## V2500 A5/D5 SERIES PROPULSION SYSTEMS SERVICE BULLETIN

This document transmits Revision 7 to Service Bulletin EV2500-72-0302

# V2500-ENG-72-0302

ENGINE – HP TURBINE ROTOR AND STATOR ASSEMBLY – INTRODUCE FIRST AND SECOND STAGE  
TURBINE BLADES WHICH HAVE PROTECTIVE COATING IN THE DAMPER POCKET AREA UNDER THE  
PLATFORM

Location of the Stage 1 High Pressure Turbine Blade Assembly  
Figure 1

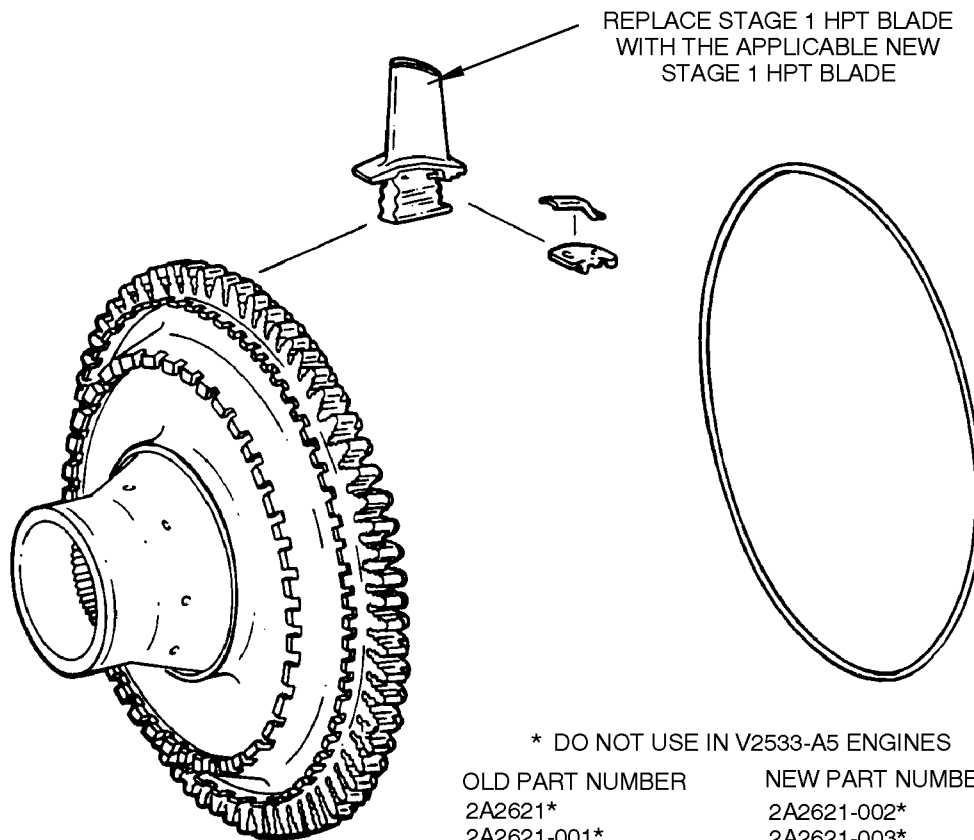
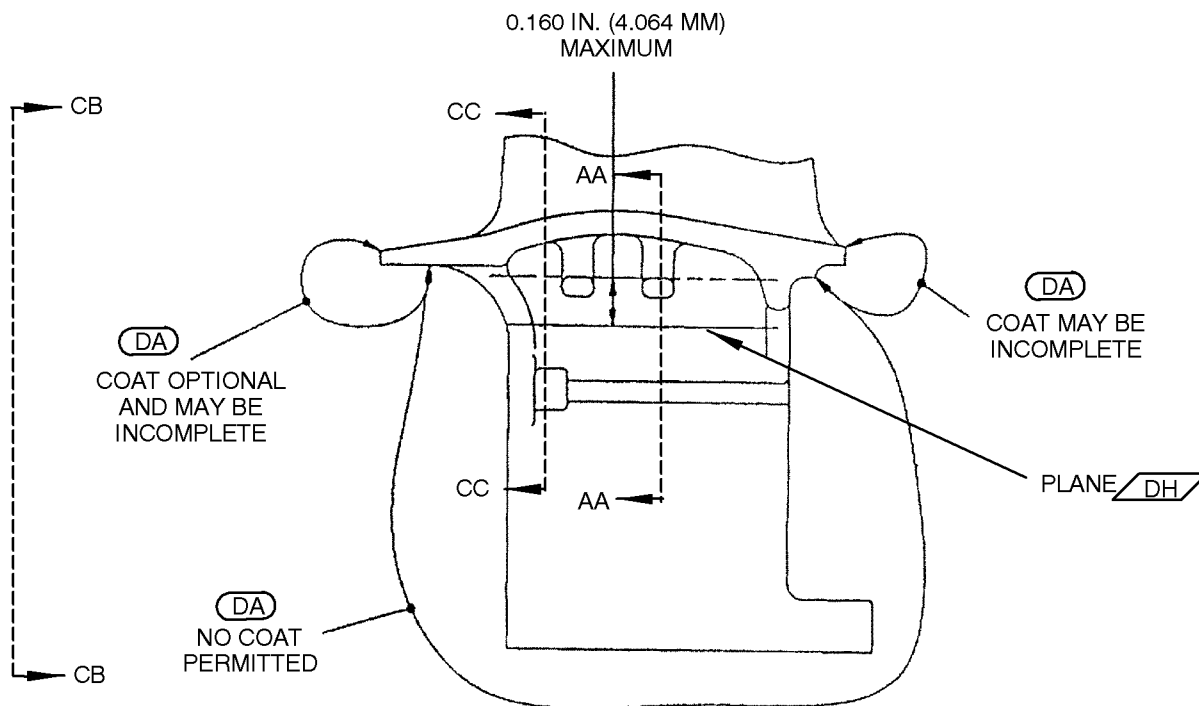
- (c) Remove the Stage 1 HPT Blades (64 off) by the approved procedure given in Reference (10) Chapter/Section 72-45-10, Disassembly-01. See Figure 1.

- (d) Remove the Stage 2 HPT Blades (72 off) by the approved procedure given in Reference (10) Chapter/Section 72-45-30, Disassembly-01. See Figure 3.

- (a) Replace the Stage 1 HPT Blades (64 off) by the approved procedure given in Reference (10), Chapter/Section 72-45-10, Assembly-01. See Figure 1.
  - (b) Replace the Stage 2 HPT Blades (72 off) by the approved procedure given in Reference (10), Chapter/Section 72-45-30, Assembly-01. See Figure 3.

Modification of the Stage 1 High Pressure Turbine Blade Assembly  
Figure 2 (Sheet 1)

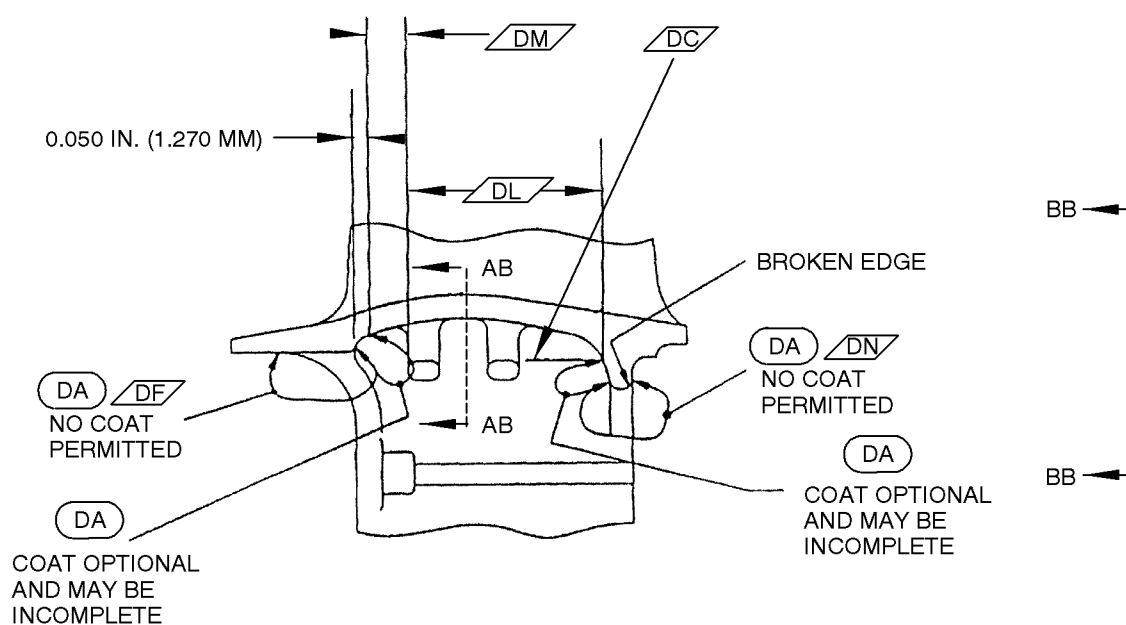
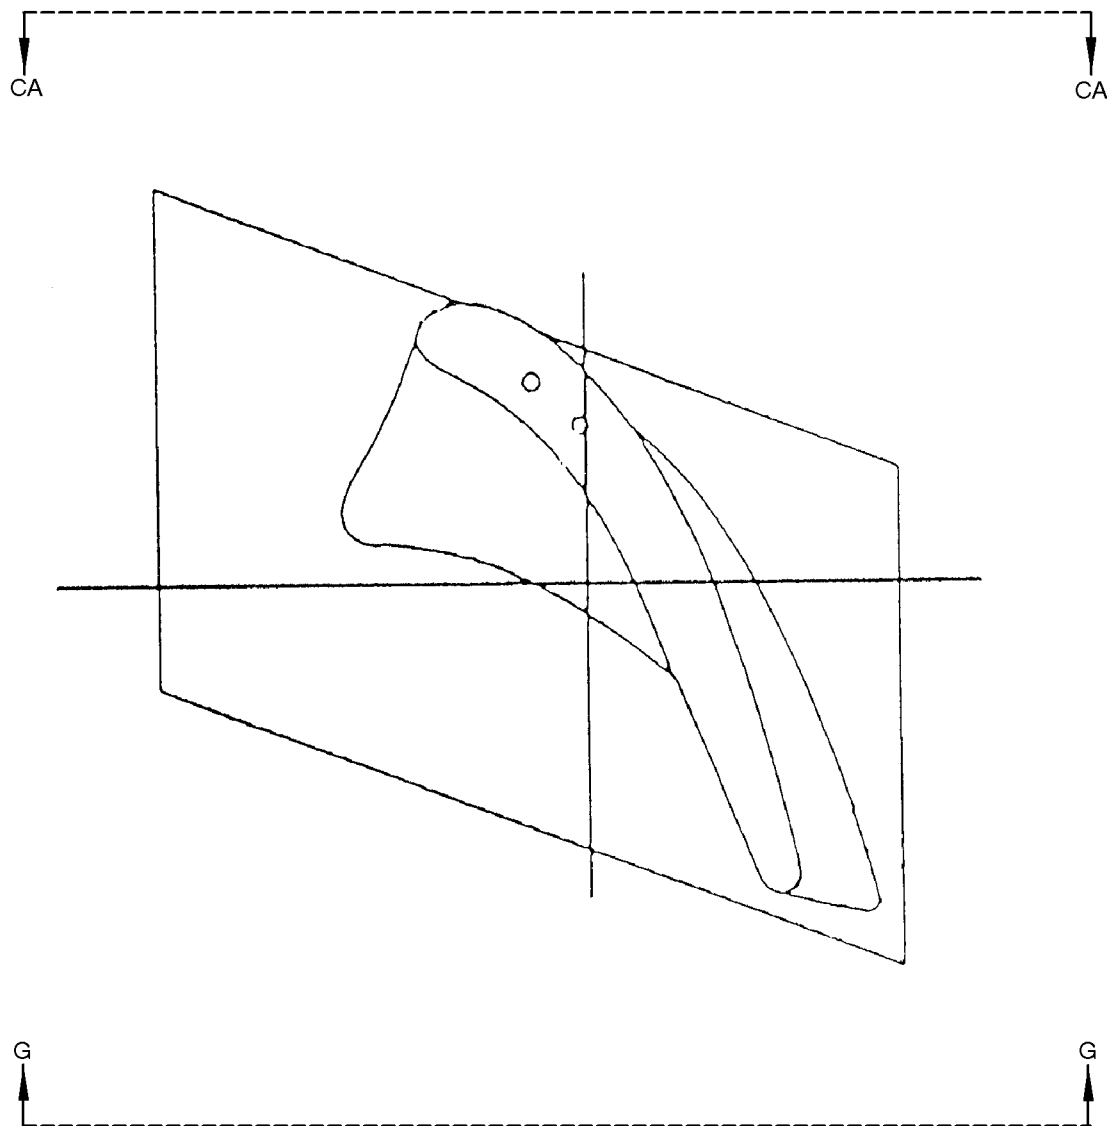
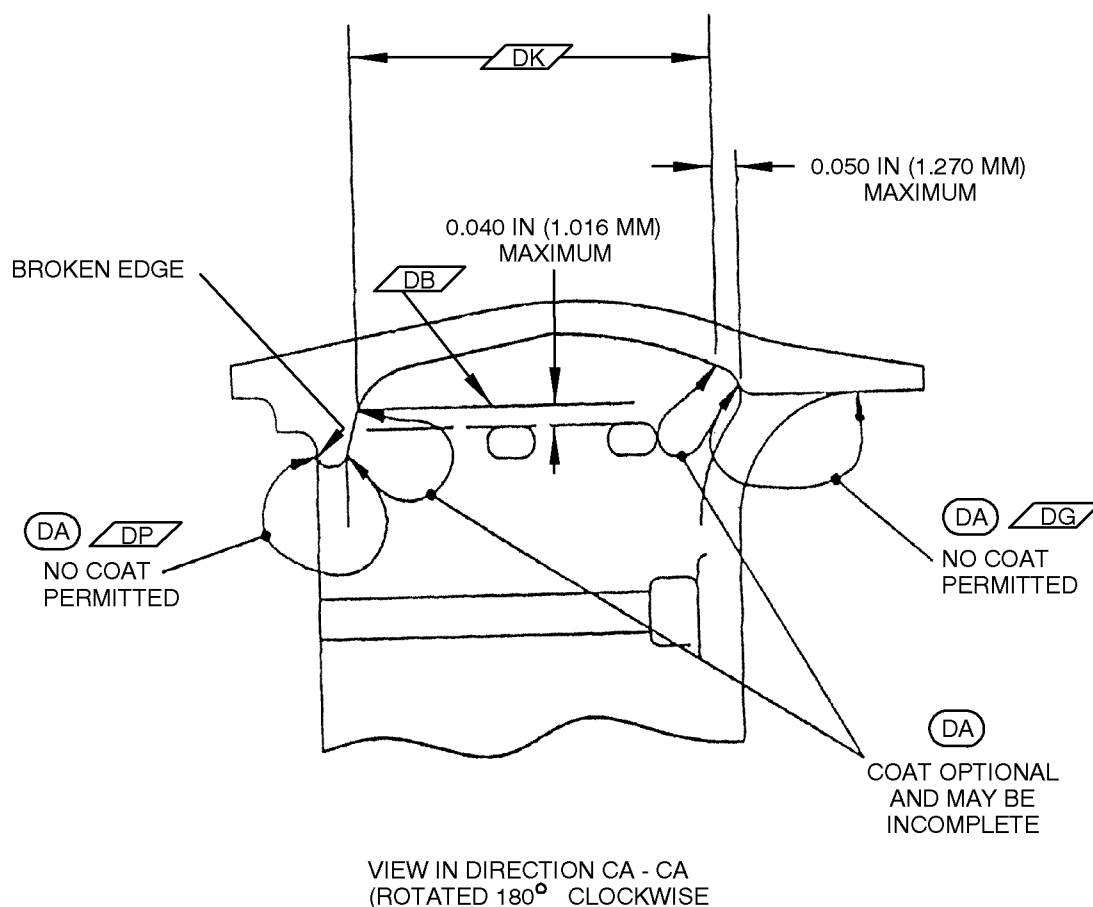
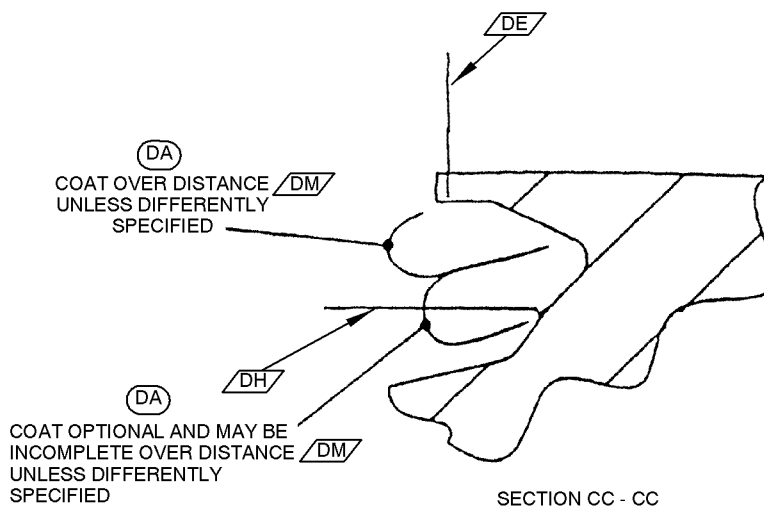
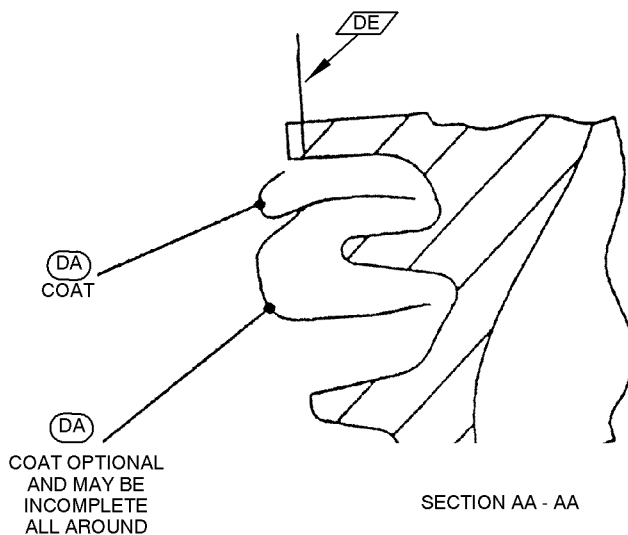
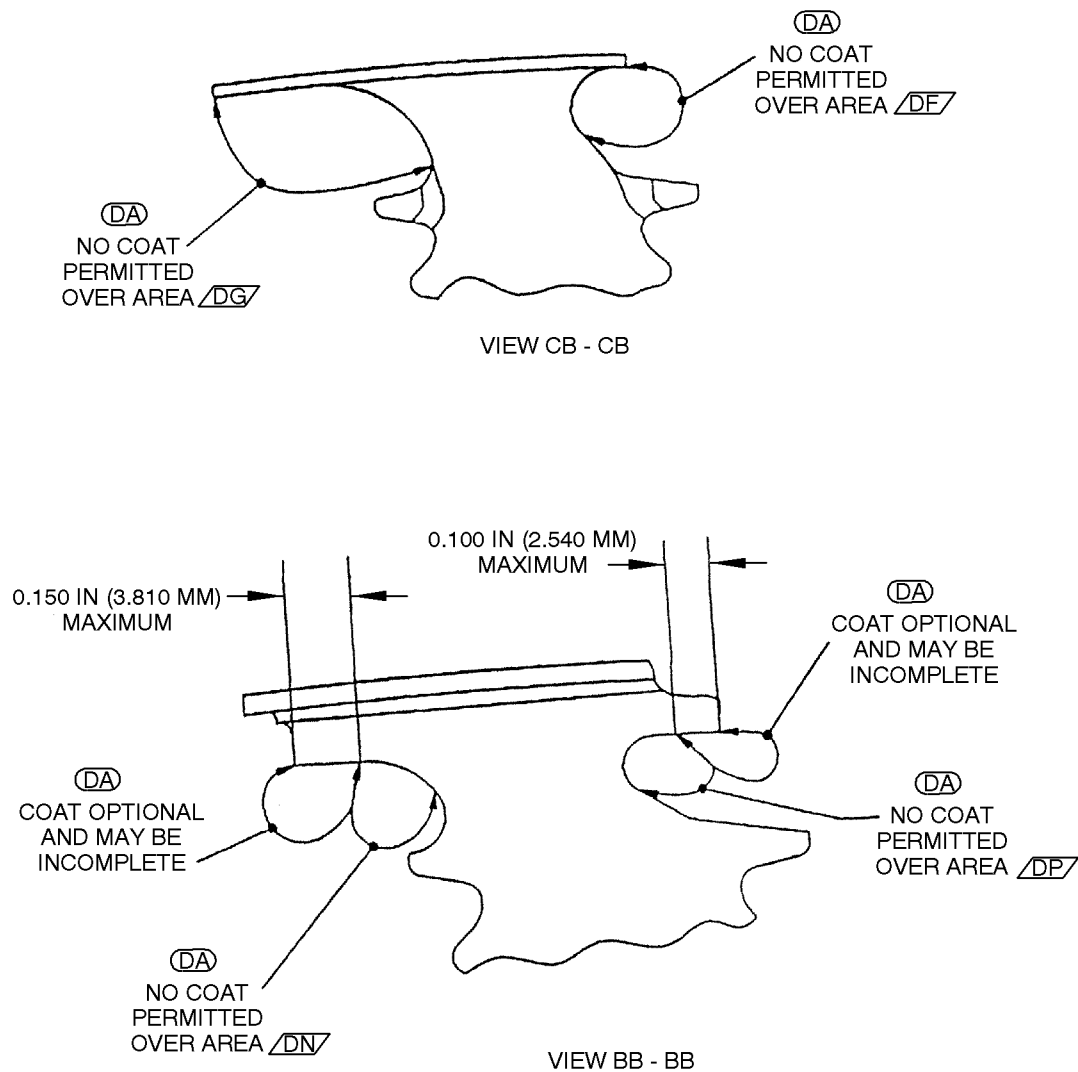
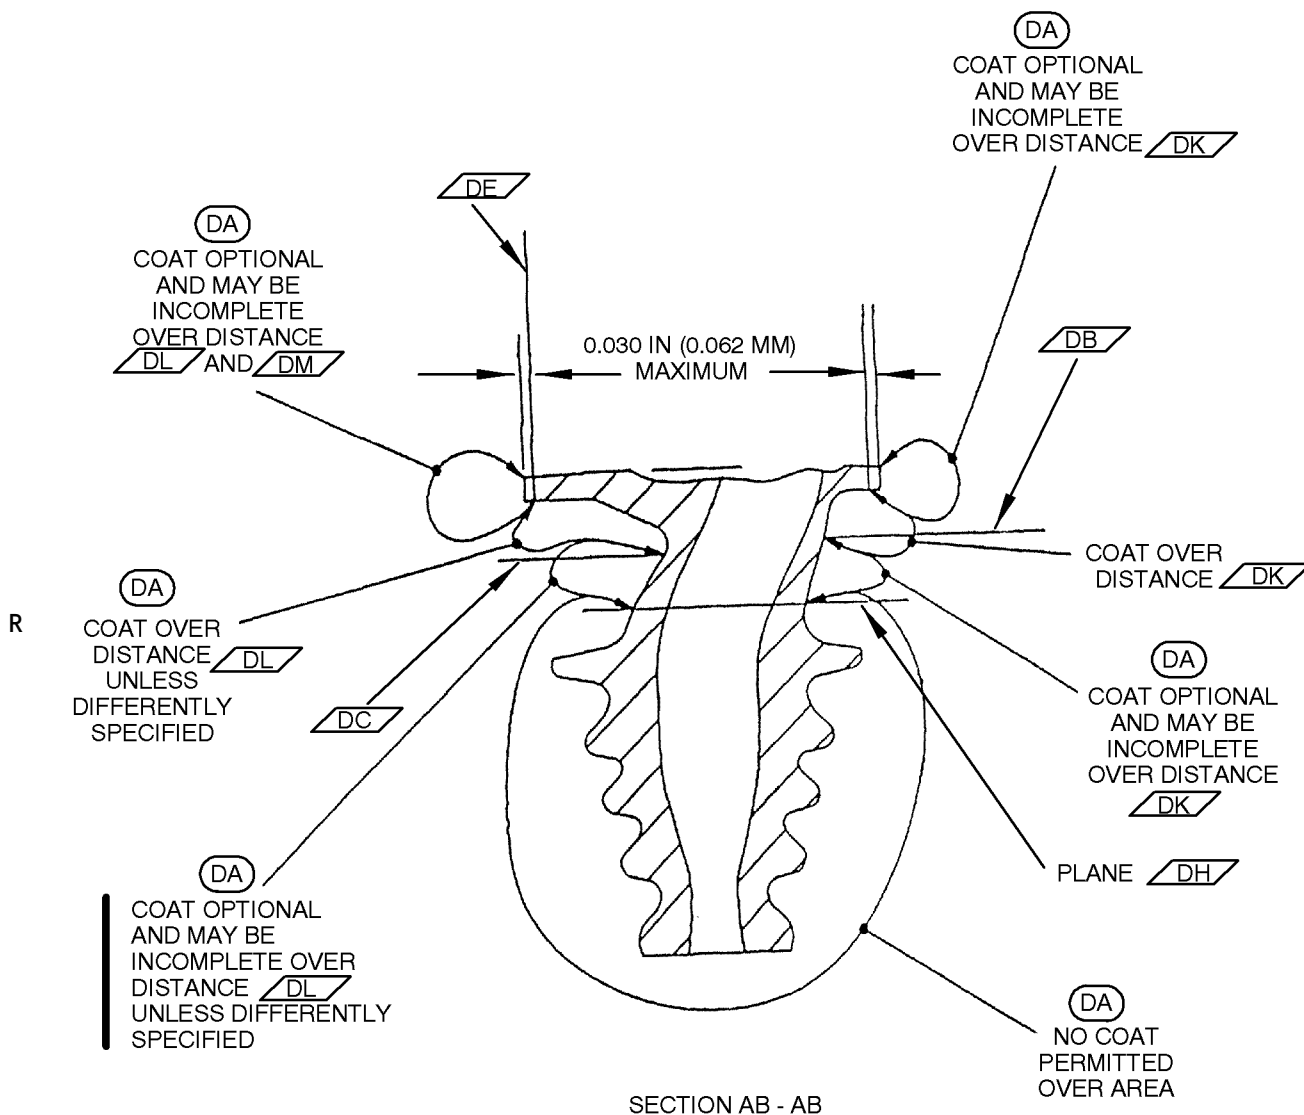
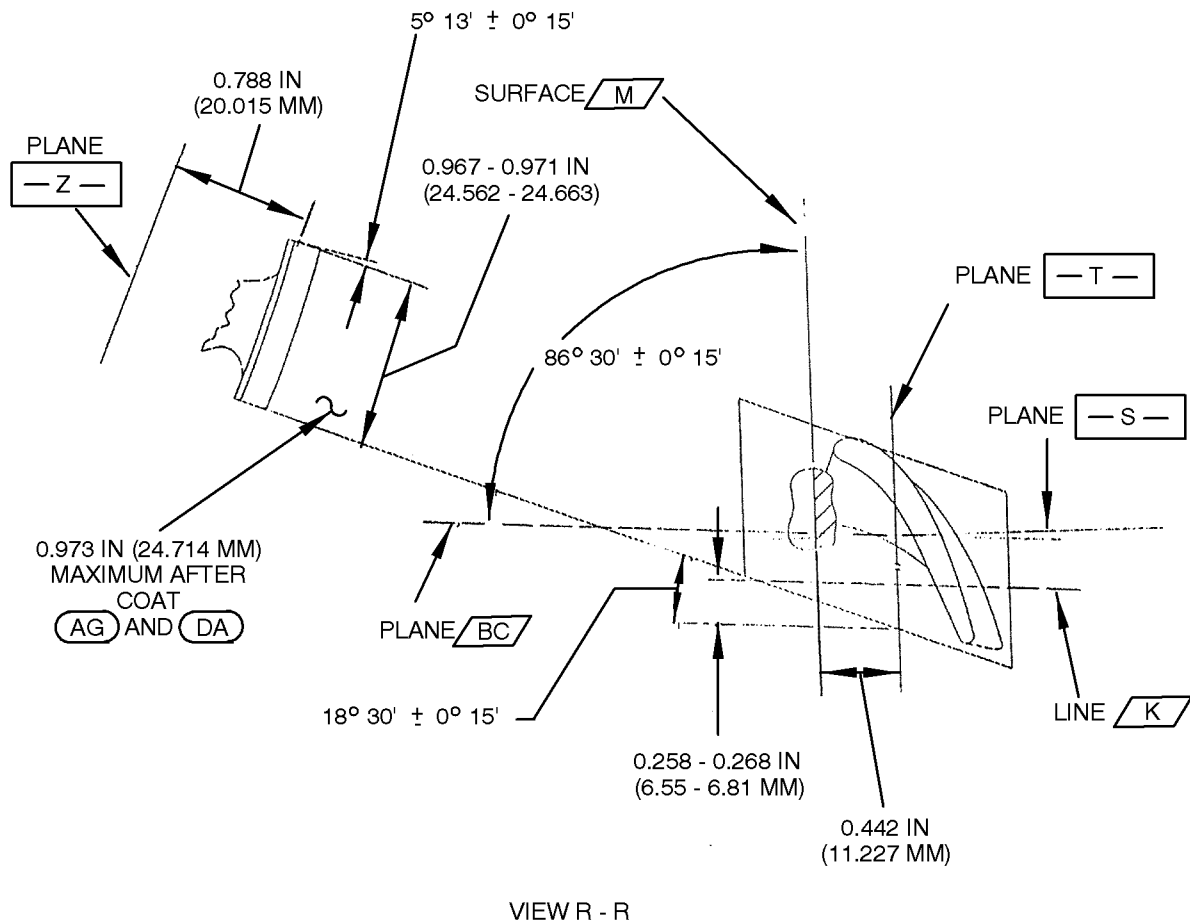
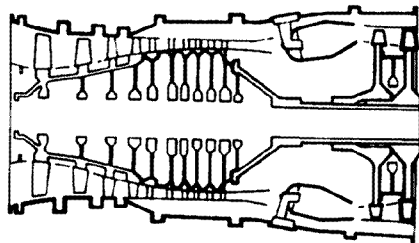
(i) Do a modification of the Stage 1 High Pressure Turbine Blades 2A2621, 2A2621-001, 2A8321, 2A8321-001, 2A8521, 2A8521-001, 2A8701 and 2A8801 (64 off). See Reference (8), Chapter/Section 72-45-14 for the applicable engine model. See Figures 1 and 2.

- (8) Dry abrasive blast the under platform area by the procedure specified. Make sure that the areas which need protection are properly masked (root serrations, root openings and coated areas).

Refer to Reference (9), Chapter/Section 70-12-09, Abrasive Cleaning. See Figure 2.

- (9) Apply protective coat to the blade under platform area by the procedure specified.

- A Use multiple coats to the blade under platform area to obtain the coating thickness requirement of 0.0005 - 0.0030 in. (0,013 - 0,076 mm) after diffusion heat treat.

- B Diffusion heat treat for 4 hours at 1950 - 2000 deg. F (1065.6 - 1093.6 deg. C) in a dry argon or dry hydrogen atmosphere.

- (10) Do a check of the under platform area for the presence of coating by the procedure specified.

Refer to Reference (9) Chapter/Section 70-28-01, Special Inspection. See Figure 2.

- (11) Touch-up under platform areas that have insufficient coating by the procedure specified.

Refer to Reference (9) Chapter/Section 70-38-26, Surface Treating. See Figure 2.

Refer to Reference (9) Chapter/Section 70-37-03 Heat Treating. See Figure 2.

Location of the Stage 2 High Pressure Turbine Blade Assembly  
Figure 3

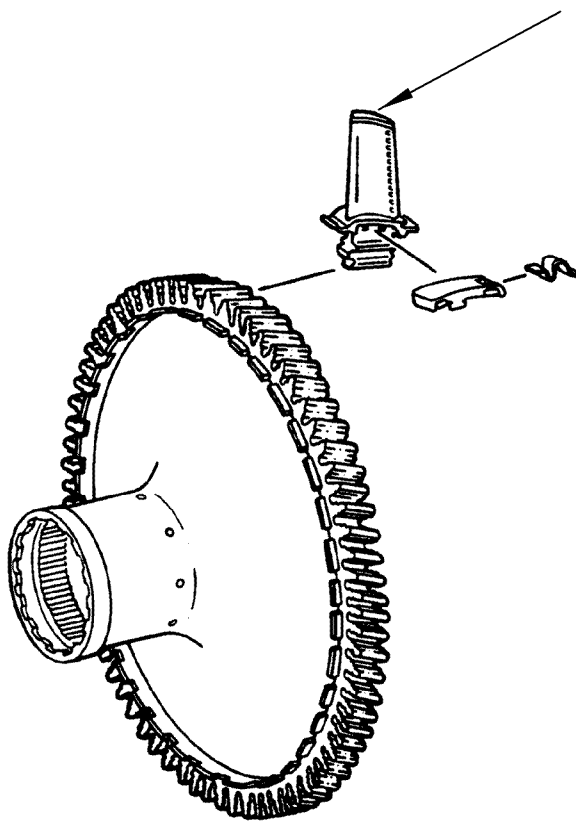
REPLACE THE STAGE 2 HPT BLADE  
WITH THE APPLICABLE NEW  
STAGE 2 HPT BLADE ASSEMBLY
